# **FOWEREX** Product Change Notification

## LD41 60 POW-R-BLOK™Is Discontinued LDR1\_\_66 To Be Offered as Replacement

#: 2021-012 Rev.: 01

#### **OUTLINE DRAWING**

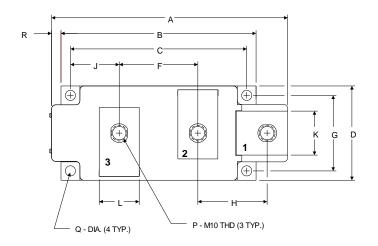
Mechanical differences between the LD41\_60 modules and LDR1\_66 modules include, but are not limited to, the following:

Dimension	LD41 (mm)	LDR1 (mm)	
Α	150	149	
L	25.4	26	
M	17.5	17	
R	6	5
